CONSTRUCTION DOCUMENTS FOR HONOR CHARTER SCHOOL

COVER SHEET

GENERAL NOTES HONOR CHARTER SCHOOL HIGHMARK SCHOOL DEVELOPMENT 8250 BEAT GRASS MEADOWS DR.							
DRAWING CW	DATE: 11/11/2024	CHECKED:	DATE:	REVISION #:	DATE:	JOB NO. C01517	
PREPARED UNDER THE SUPERVISION OF TAIT & ASSOCIATES, INC.							2 OF 48
BRIAN CAMPBELL COLORADO P.E. #40196							2/6/2024 Internal Review #1

NORTHEAST GRADING PLAN

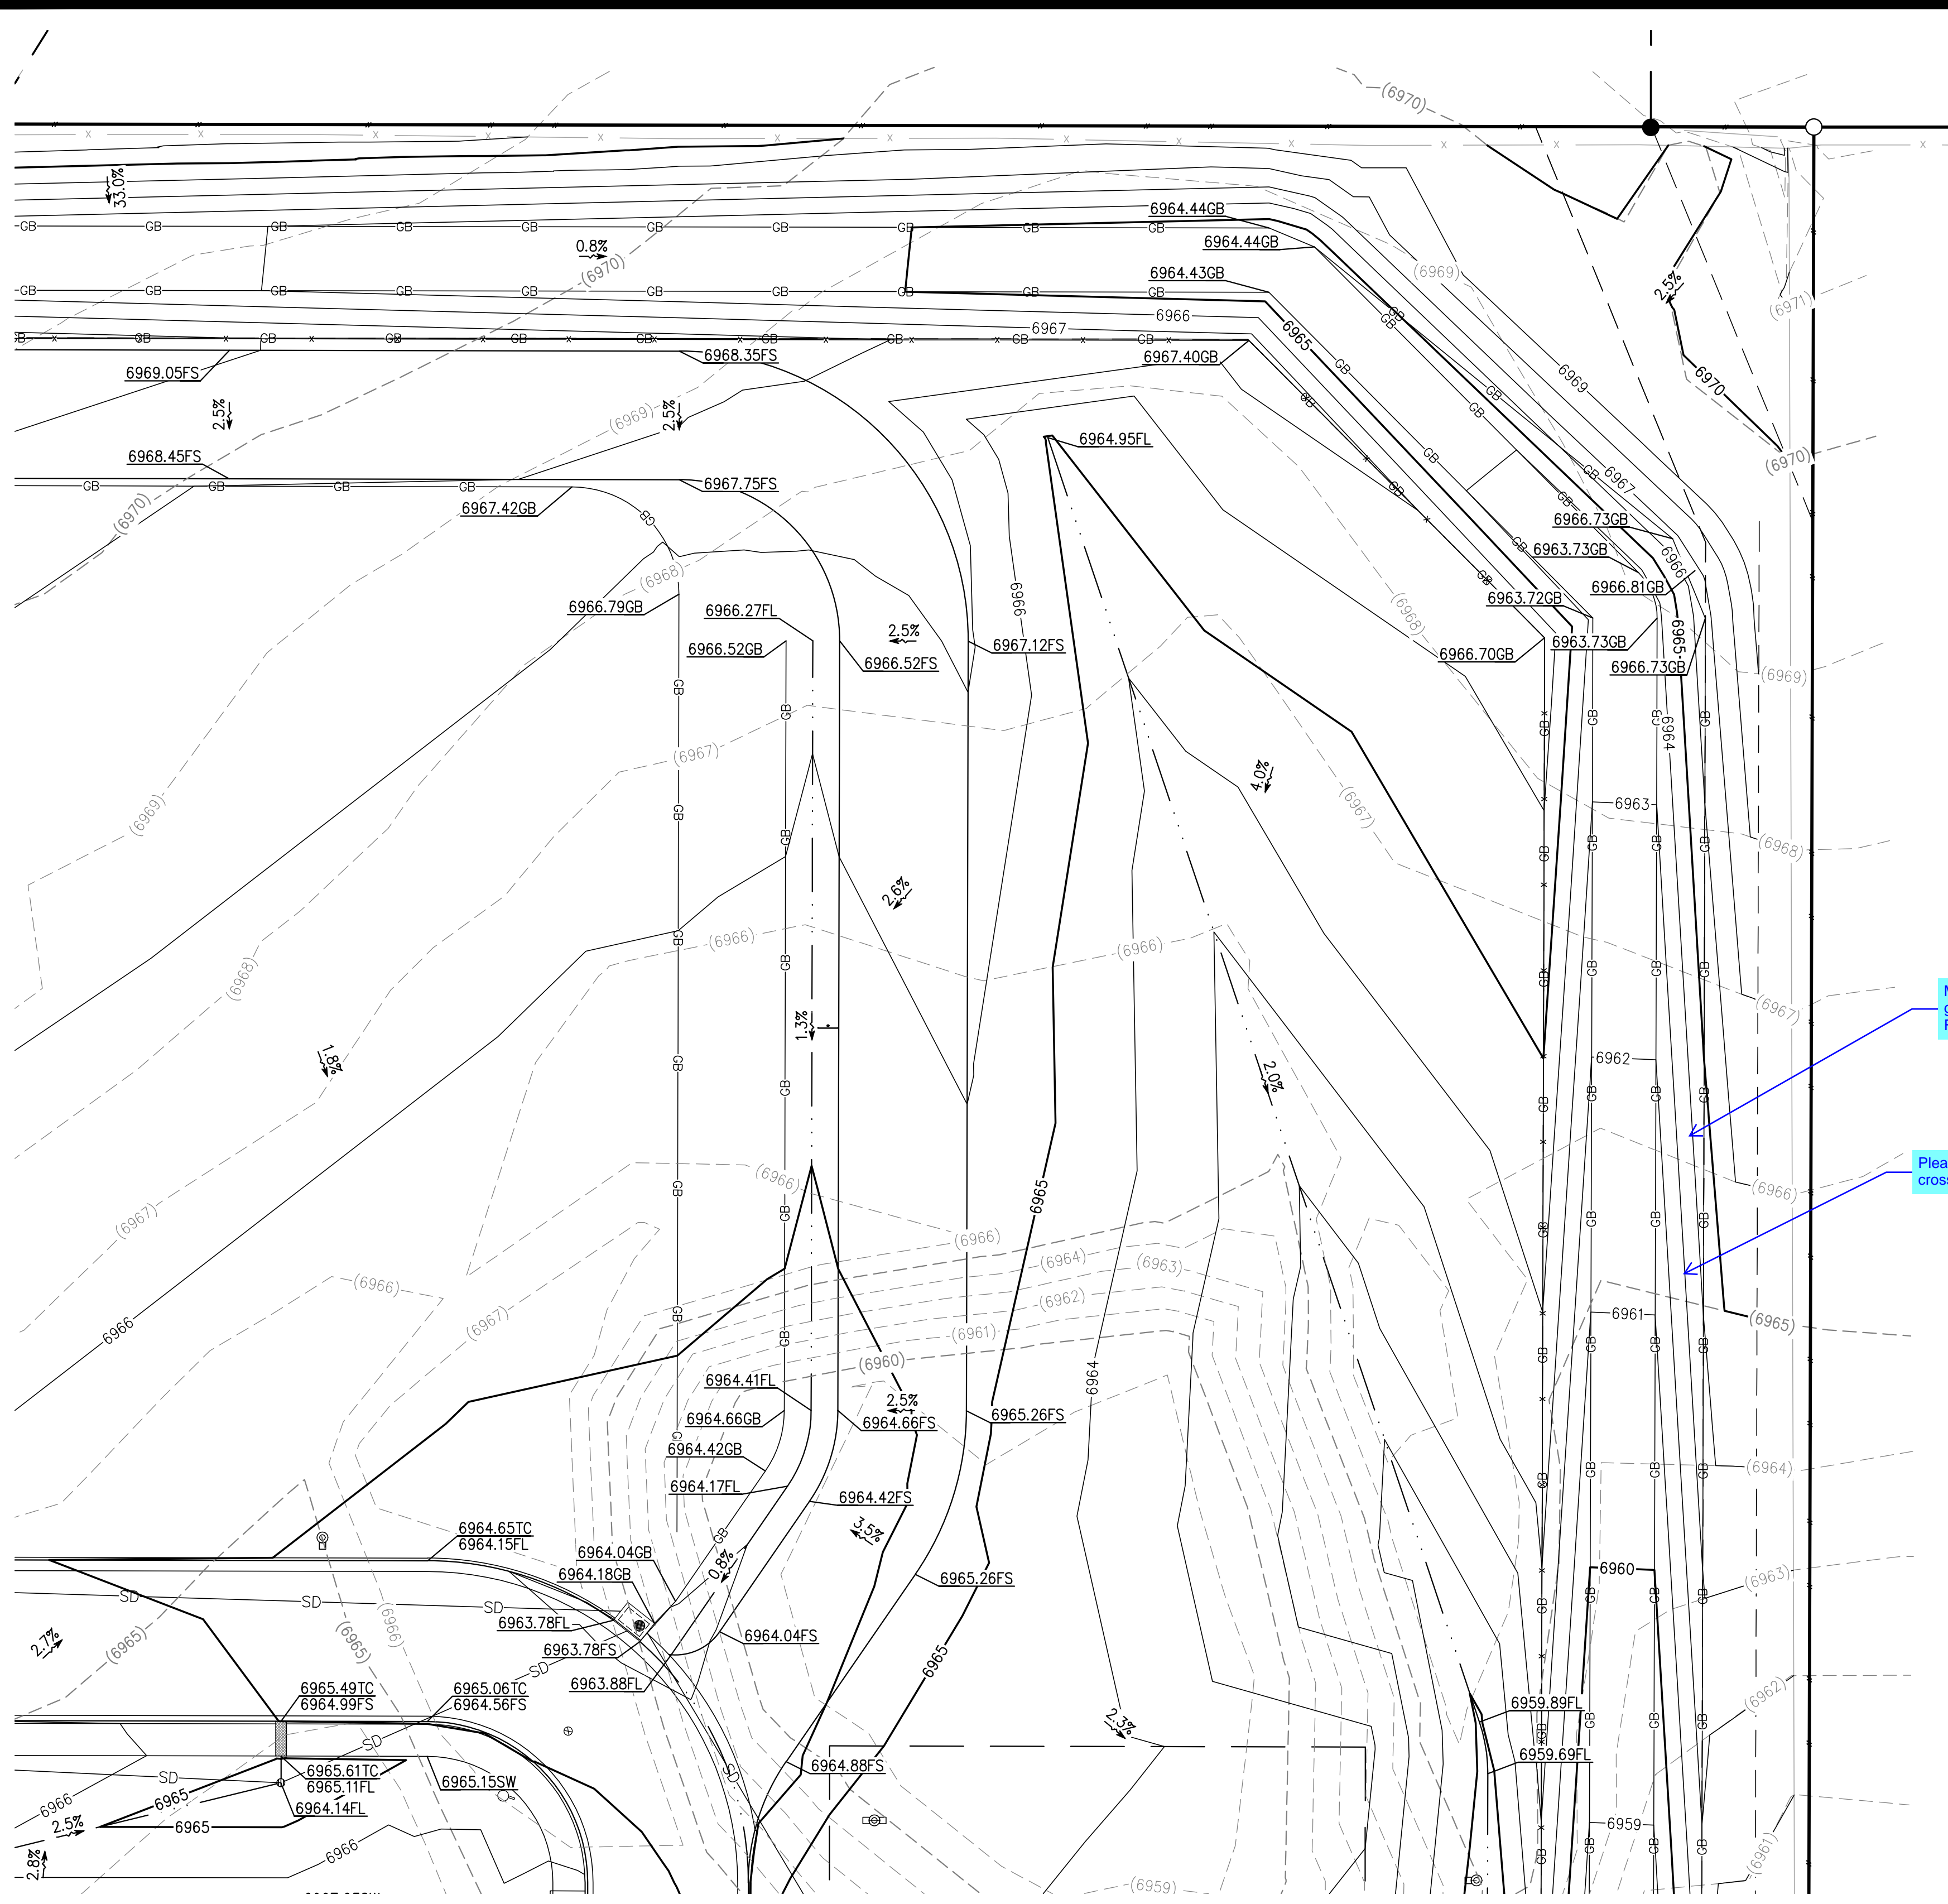
Maximum side slope for grass-lined channel is 4:1. Revise design.

Please provide channel cross-section detail.

GRADING DETAIL 3

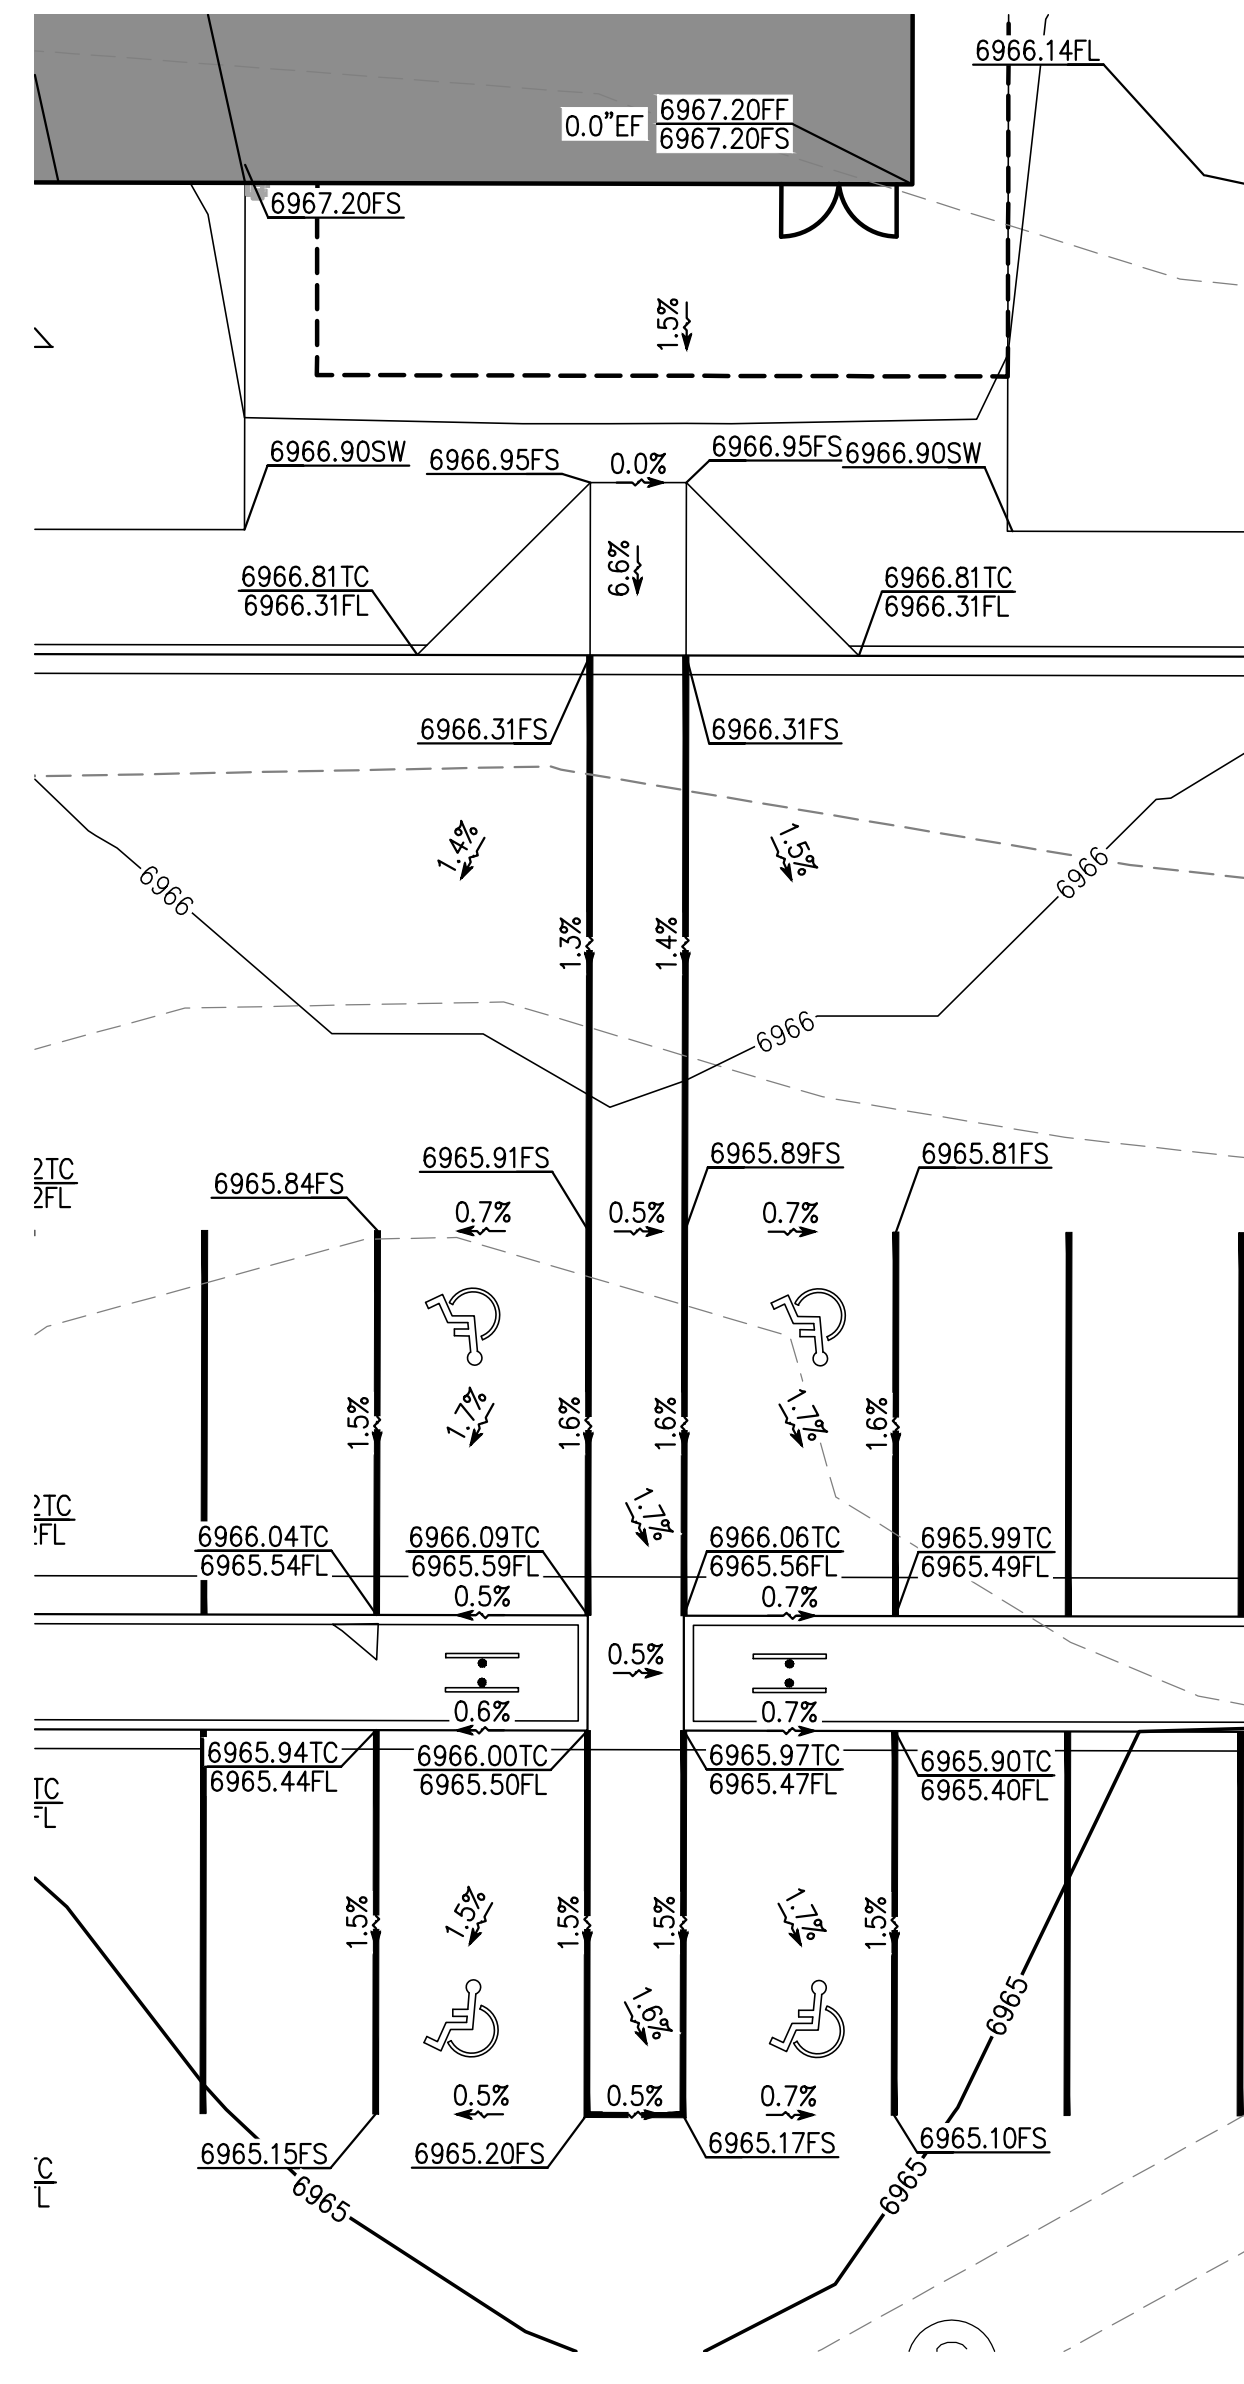
It appears that either the ADA ramp layout or the grading was revised without updating the other, including the associated spot elevations. Please revise for consistency.

STORMWATER PROFILE 1

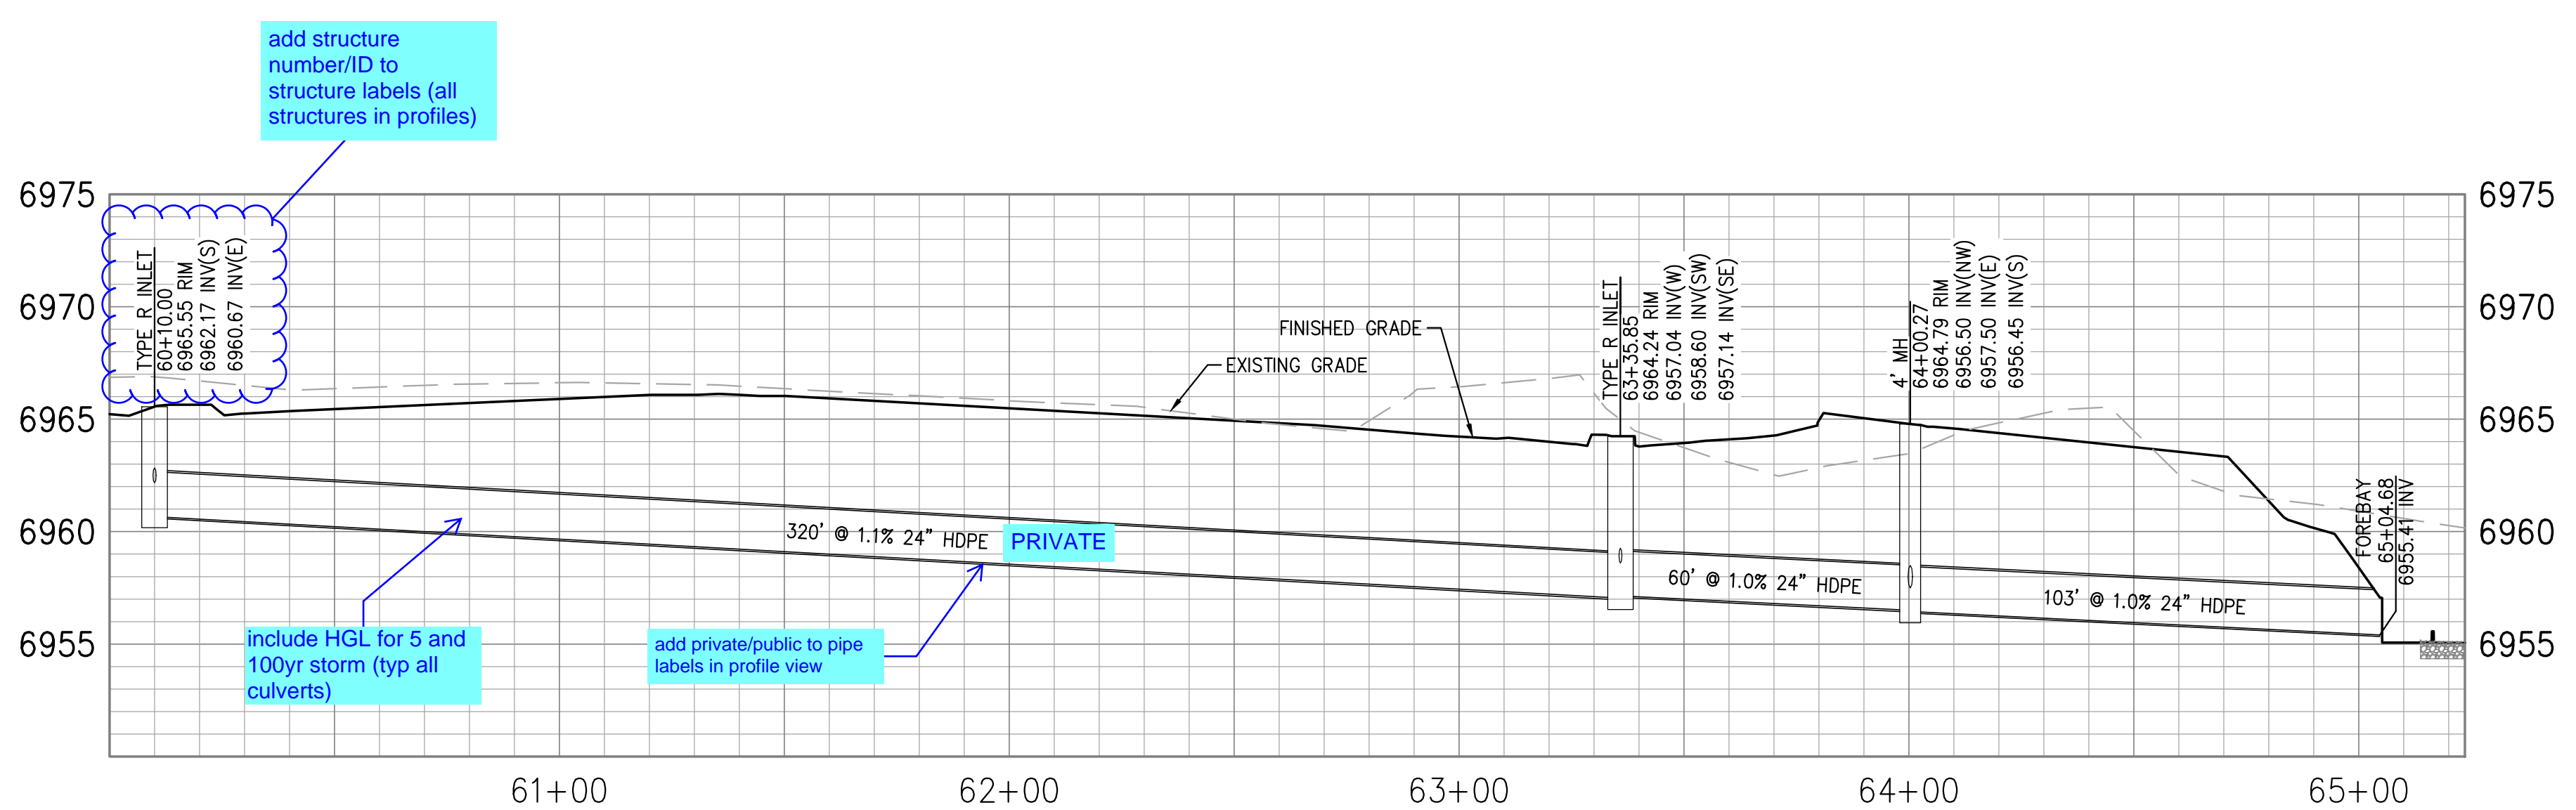
Please identify what these arrows represent.
